Norwich to Tilbury Development Consent Order

Landscape and Visual Technical Note

Examination Deadline 5 Submission

On behalf of Villages against Pylons

Figure 1: Technical Note Study Area overlay (Extract from: Figure 13.1 – Landscape and Visual – LVIA Study Area and Landscape Designations Page 8 of 13 – Drawing no. 10059280-ARC-ELS-ZZ-DR-ZZ-00238)

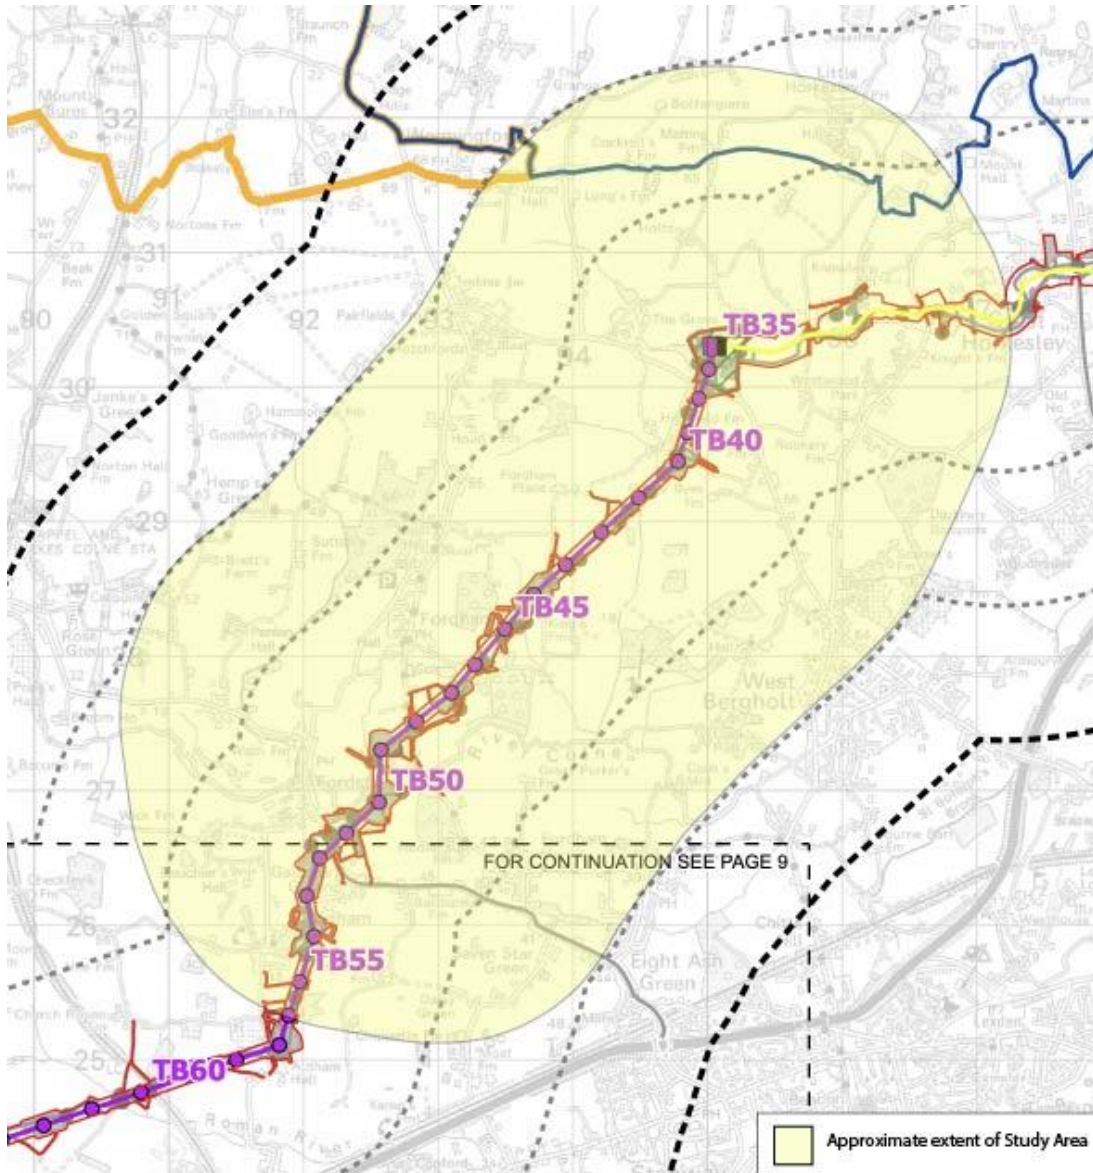
For the purposes of this review, particular focus has been given to the section of the proposed overhead line alignment extending between the proposed sealing end compound (Figure 1) at TB35 and TB50 east of Fordstreet. This section traverses the Colne Valley between West Bergholt, Eight Ash Green, Fordham and Fordstreet and represents an area within which the proposed pylons would be closely associated with the valley landscape. The review therefore concentrates on the landscape and visual receptors within approximately 2km of the alignment, including the Essex Way, surrounding PRow network, local communities and local roads.

Figure 5: Colne Valley Recreational Receptors (Extract from: Figure 15.3 - Socio-economics, Recreation and Tourism - Recreational Land and Recreational Routes Page 15 of 24 – Drawing no. 10059280-ARC-EGN-ZZ-DR-ZZ-00292)

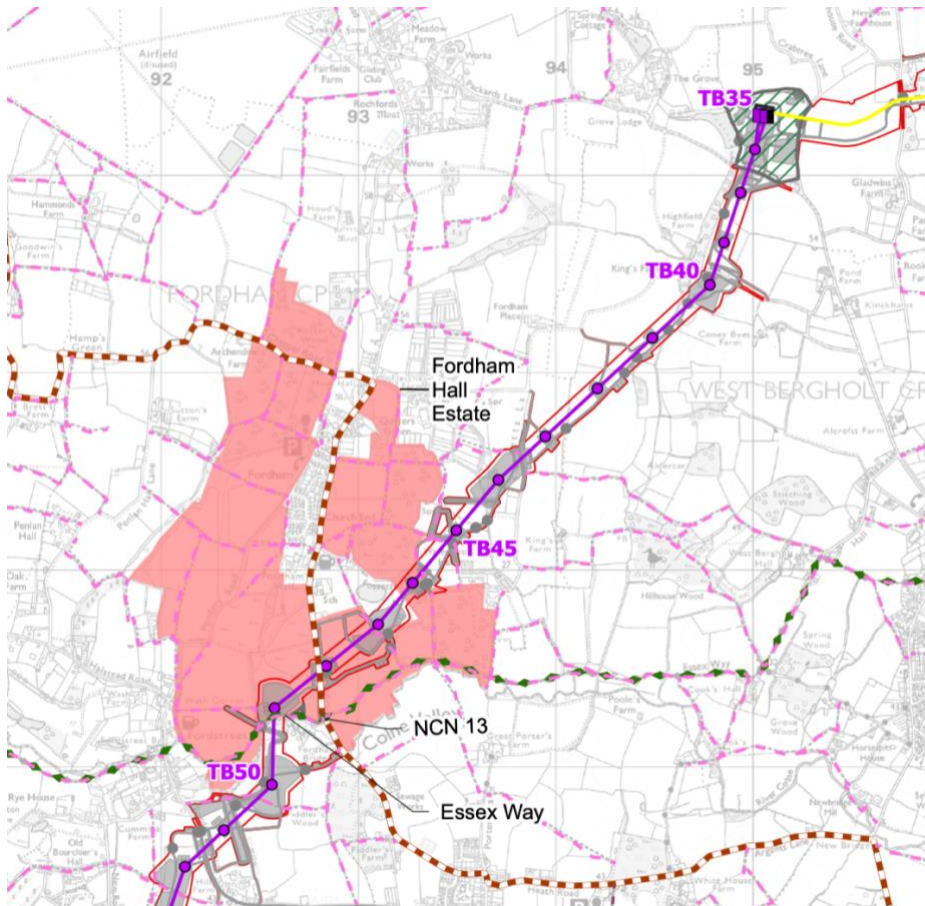
Whilst the Applicant's assessment identifies the wider LCAs as being of medium-high value overall, the broader scale of assessment may moderate or dilute the value of the specific areas directly affected by the proposed alignment. In this respect, the immediate route corridor appears to exhibit characteristics more closely aligned with higher landscape value than is reflected within the wider baseline assessment presented within the Environmental Statement.
